Pacific Gas and Electric Company

Estrella Substation and Paso Robles Reinforcement Project

Proponent's Environmental Assessment (A.17-01-023)

Response to CPUC Data Request No. 3

Paso Robles Load in Summer (from 2018-07-06 to 2018-08-18)

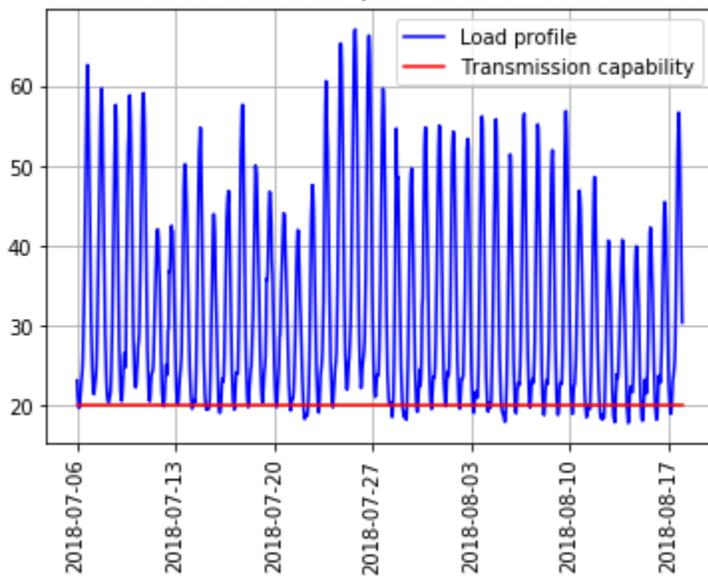
PG&E agrees with the Draft ASR analysis of energy storage in megawatts (MW) and megawatt-hours (MWh) needed to address reliability criteria per North American Electric Reliability Council (NERC) TPL-001-4 P1 requirements (PG&E comments on pdf p. 21) but suggests that a transmission-level battery storage solution is not an adequate alternative to the Proposed Project. PG&E bases this on the potential for a second 70 kV outage occurring subsequent to the restoration of an initial 70 kV outage that impacts the same Paso Robles Substation, with both outages lasting at least 24 hours. We assume that PG&E would agree that sequential, transmission-level outages, impacting the same substation are rare occurrences. Please provide evidence supporting PG&E concerns about the risk of not only one but two 24-hour outages occurring with the second occurring before the battery can sufficiently recharge. The response should include a record of similar historical outages within PG&E's service area that impacted the same substation, which would have eliminated the ability to charge a battery.

When we stated that we agree with ZGlobal's analysis of the MW and MWh sizing of the transmission connected BESS at the Paso Robles Substation in order to meet the NERC TPL-001-4 (P1) (N-1) requirement, we meant that we agreed that a battery with storage capacity of 65 MW / 715 MWh would be sufficient to sustain load at Paso Robles Substation for 24 hours if the system was in an N-1 condition resulting from a loss of the Templeton-Paso Robles 70 kV line;

we meant nothing more. As we stated on PDF page 20 of our comments on the Draft ASR, “Alternative BS-1C is sized to address an outage of 24 hours.” However, we were not stating that we agree that connecting a battery of this size will comply with the NERC TPL-001-4 (P1) standard. It will not, as we explained in our response to Item 1 above (citing also to CAISO’s responses to this data request) and as detailed further below.

Compliance with the NERC TPL-001-4 (P1) standard requires that the 70 kV system must have the capability to return to the normal state when the N-1 event is resolved. In other words, after the N-1 event is resolved the system must return to a state in which no load will be dropped if another N-1 event occurs. A BESS with a storage capacity of 65 MW / 715 MWh connected to the Templeton-Paso Robles 70 kV line cannot secure against load drop under all scenarios. If a 24-hour outage of the Templeton-Paso Robles 70 kV line occurred, the BESS would be completely discharged and, therefore, would not be ready to pick up load when the Templeton-Paso Robles 70 kV line is restored. During the peak summer months there are many days in which little to no charging of the battery would be possible. As shown in Figure 2 in our comments on the Draft ASR, there are days during the summer in which the minimum load demand is greater than the maximum of 20 MW that can be supplied by the Paso Robles-San Miguel 70 kV line. We are supplementing Figure 2 in our comments on the Draft ASR with the following figure showing load data at the substation for the period July 6 to August 18, 2018, which further demonstrates that there will be no charging window or an insufficient charging window during the summer peak period. If the system is in an N-1 condition for greater than 24 hours during this period, the battery will not be able to recharge at all and unable to secure the system against another N-1 contingency.

The transmission level BESS introduces uncertainty into the NERC compliance equation, which is not allowed. The NERC standard is a strict compliance standard. The BESS provides a solution for only as much power as it can store. The Proposed Project, by contrast, would provide a redundant 70 kV source to Paso Robles Substation that can provide power to the substation if the Templeton-Paso Robles 70 kV line has an outage, for as long as necessary. Accordingly, the
